Licence Number	L8986/2016/1
Licence Holder	Holcim (Australia) Pty Ltd
ACN	099 732 297
File Number:	DER2016/001471-1
Premises	Jandabup Sand Quarry JANDABUP WA 6077 Mining tenements M70/1248 and M70/1250 360 Hawkins Road, JANDABUP WA 6077
Date of Amendment	11 September 2019

Amendment

This notice is limited only to an application received by the Department of Water and Environmental Regulation (DWER) on 24 December 2018 to amend the Existing Licence to include the operation of a new screening wash plant coupled with a rinser (wash plant/rinser), including the construction of a sediment pond to be used for storage and recovery of wastewater from washing activities at Jandabup Sand Quarry (the Premises). There are no changes to the daily throughputs as a result of this Notice and no other changes to the aspects of the Existing Licence relating to Category 12 have been requested by the Licence Holder.

Figure 1: Indicative layout of proposed wash plant.

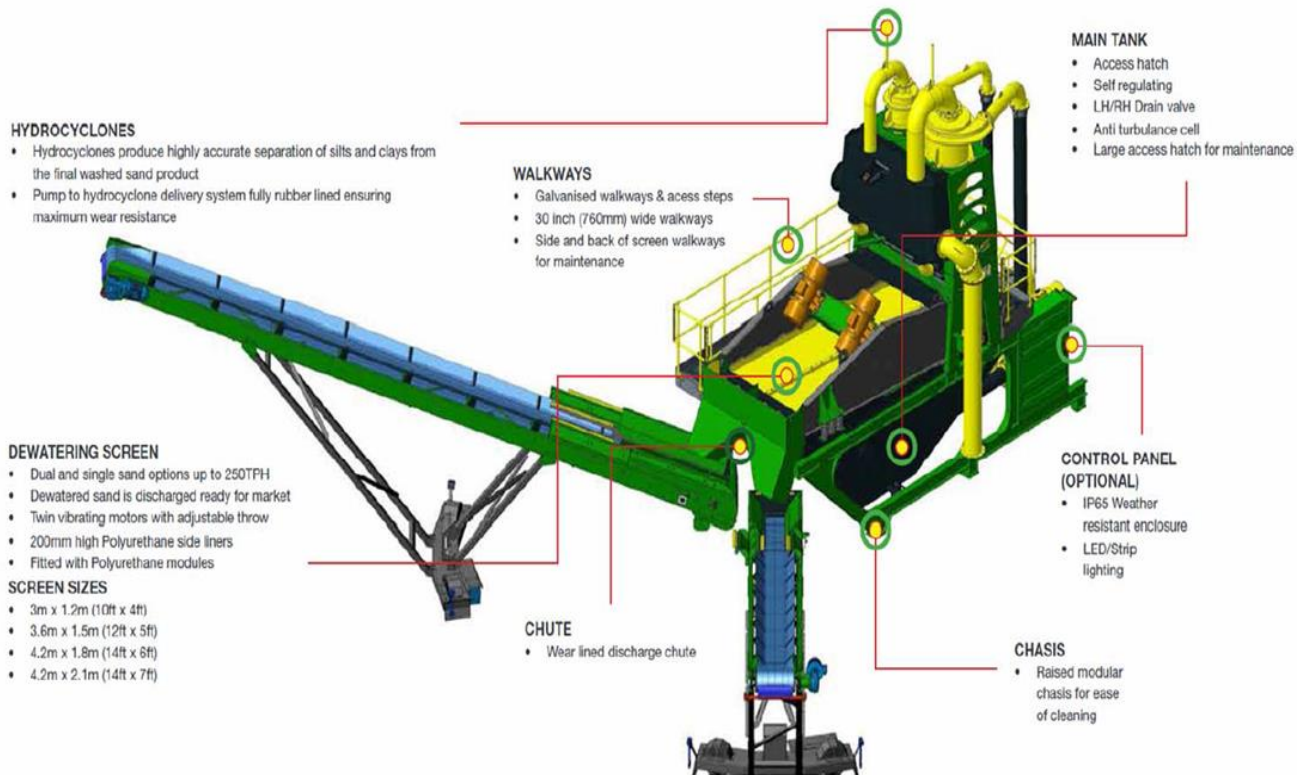
The proposed mobile washing system utilises water to screen and separate raw sand to produce sand of various size specifications that is washed, then rinsed and finally stockpiled to be later loaded into trucks and hauled offsite. The indicative layout of the wash plant and rinser is shown in Figures 1 and 2 below.

- Equipment description includes a mobile, skid-mounted screening, washing and conveyor plants driven by a diesel motor and 200kVA genset.
- Washing process will involve physical separation techniques – no chemical additives will be used. The fines (about 3% by volume of the feed material) will be piped to a sedimentation pond for drying and water recovery.

Figure 3: Layout of sedimentation pond with wedge pit and GeoPro desludging bag.

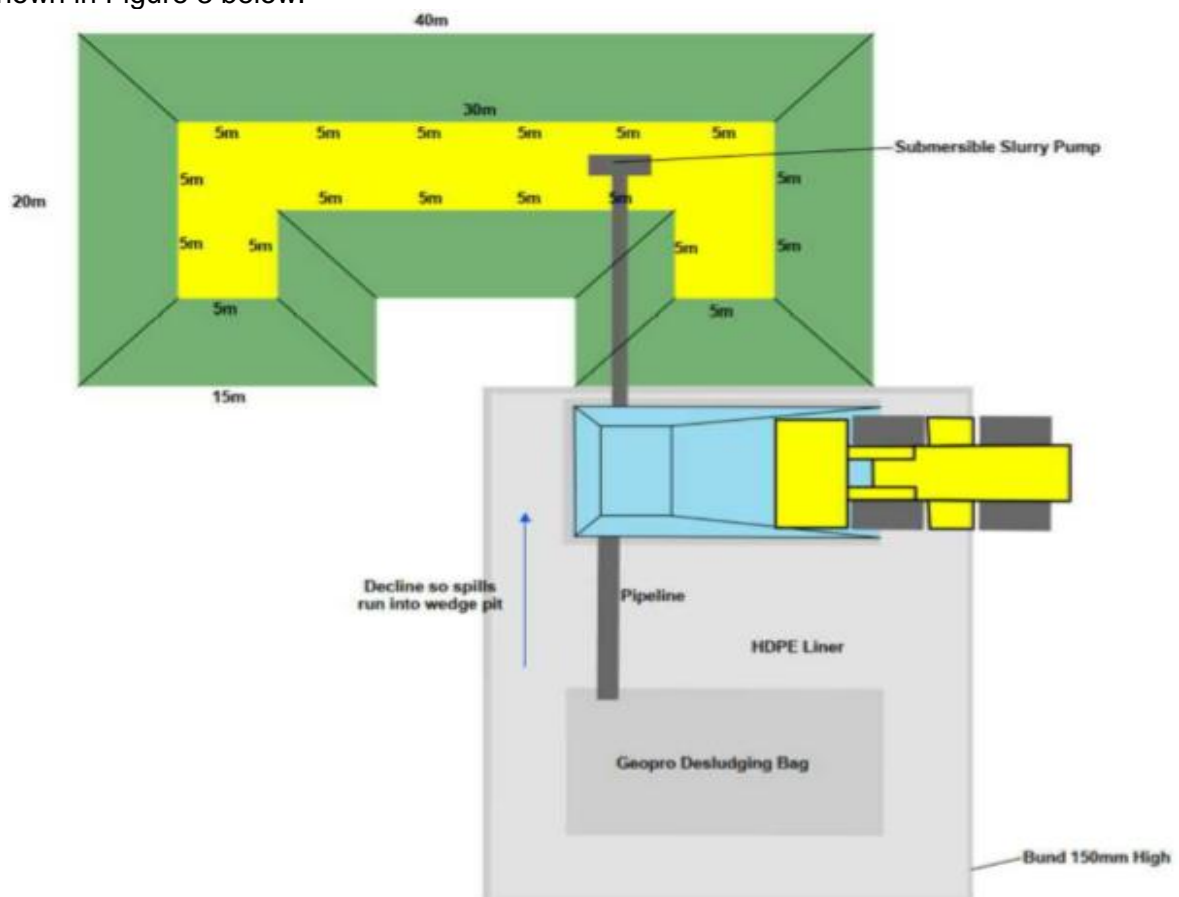
- The Licence Holder proposes that the sediment pond will be designed to withstand a 1 in 100 year, 72 hour rain event and will not exceed a total area of 800 m².

- The depth of the sediment pond will not exceed 2 m and is expected to have the capacity to store 900 kL of wastewater.
- The pond will have a 1.5mm thickness HDPE liner, which will extend across the pond and over the embankments. The pond embankments will be covered by the 1.5mm thickness HDPE liner.

- Accumulated sediment in the pond will be removed every three months or as required by a submersible slurry pump located in the wedge pit. The sediment will be pumped via a short pipeline to a GeoPro desludging bag located on a small bunded desludging pad located next to the wedge pit that will be lined with 1.5mm thickness HDPE. The desludging pad housing the GeoPro bag will be on an incline to drain any water filtered from the bag back to the wedge pit. The pad's bunds will be 150mm high and be covered with the 1.5mm thickness HPDE liner. The GeoPro desludging bag will be emptied and removed from site when it is at full capacity.

- A perimeter protection berm has been proposed to surround the sediment pond and the outer embankments to prevent the risk of overflow and to maintain structural integrity and add additional freeboard.

Infrastructure /Equipment	Requirements (design and construction)	Site plan reference
Wash plant and rinser	Install a McCloskey Washing System CSP 120 and McCloskey S190 Rinser or equivalent with a maximum design capacity not exceeding 120 tonnes of washed sand per hour.	At the location depicted in Figure 2 of Schedule 1.
Sedimentation Pond	<p>The sedimentation pond must be constructed:</p> <ul style="list-style-type: none">to withstand a 1 in 100 year, 72 hour rain event;not to exceed a total footprint area of 800 m²;not to exceed a depth of 2m below pit floor level;the sides of the sediment pond will have a slope of 1:2.5 (H:V);with a 1.5mm HDPE liner that extends across the pond and over the embankments with a permeability of 1x10⁻⁹ m/s;with a perimeter protection berm that is 0.5m high, with a 1m crest width and 1.25m side slopes that surround the pond;with outer-embankments that manage erosion;with a storage capacity that does not exceed 900kL;with a lined wedge pit and desludging bag to capture and store water before discharging to the sedimentation pond; andwith pipework that is sealed and free from leaks to transport wastewater.

Figure 2: Premises map indicating the location of the wash plant/rinser and sedimentation pond.

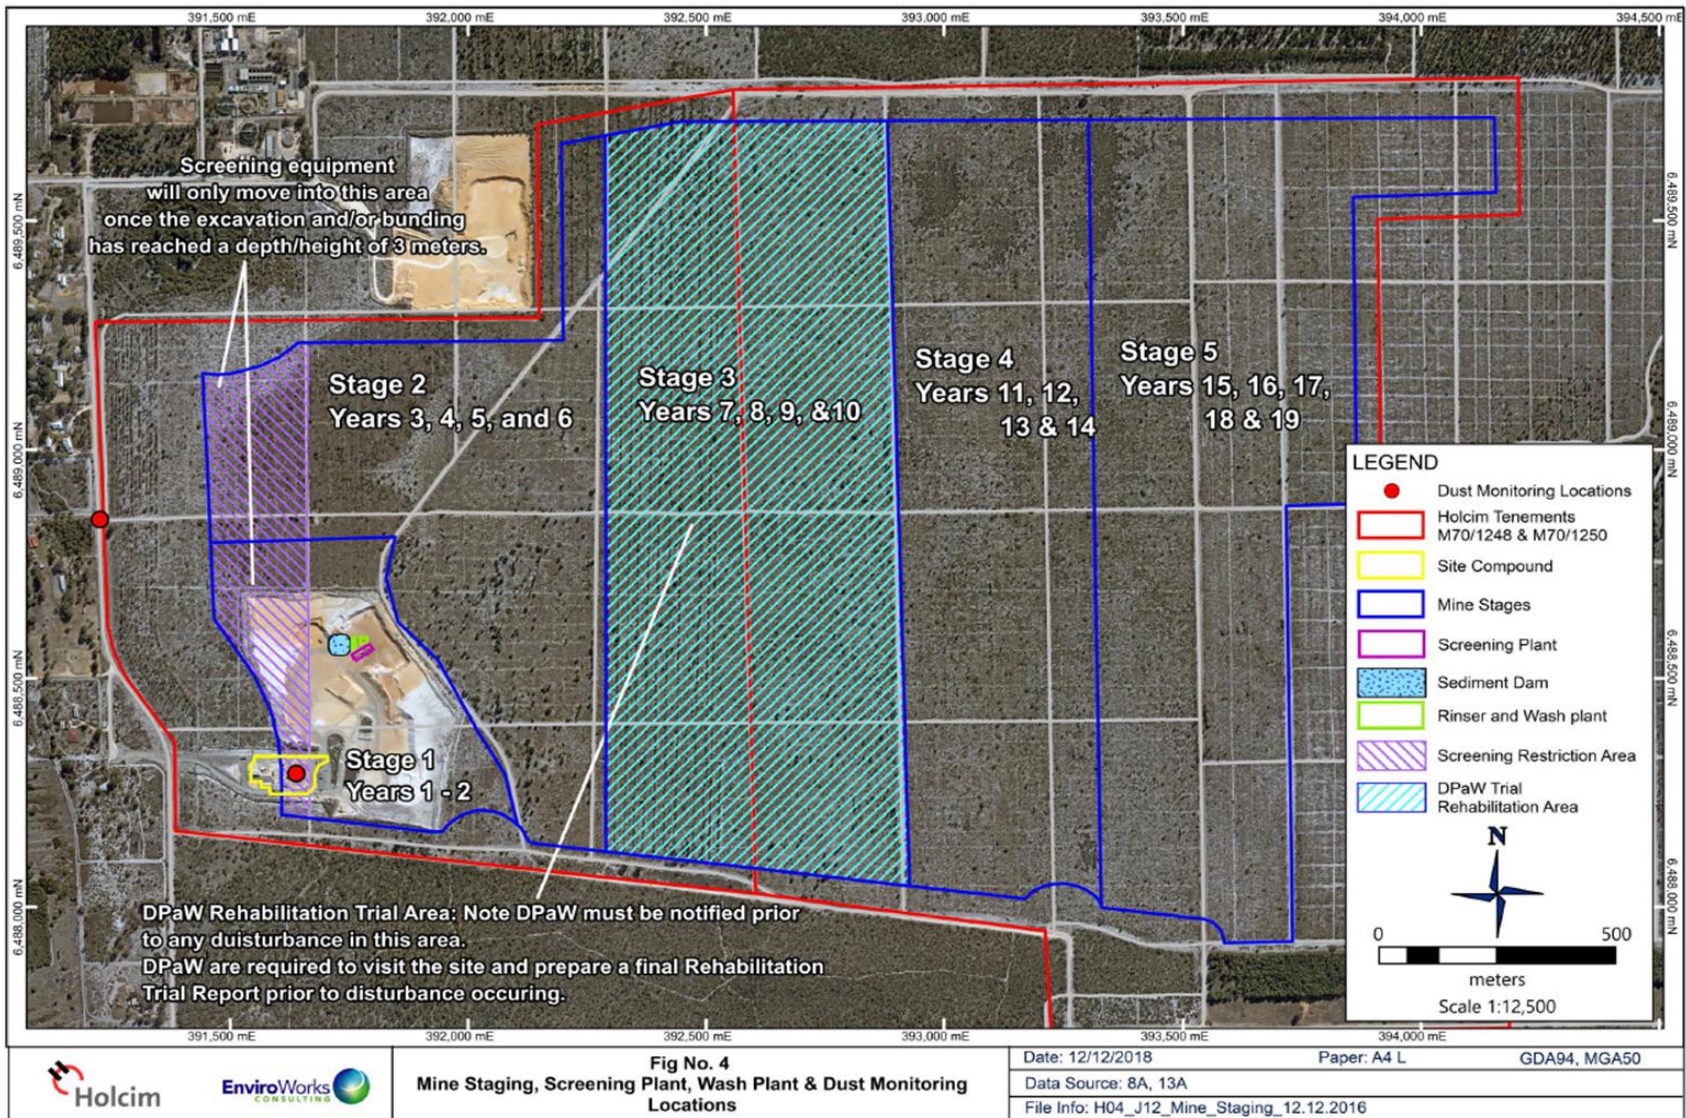
- 2. Schedule 1 of the licence is amended by the insertion of an additional map showing the location of the wash plant/rinser and sedimentation pond (Figure 2). The insertion of captions and amendments to explanatory text are shown in underline red text and the deletion of the text shown in red strikethrough.
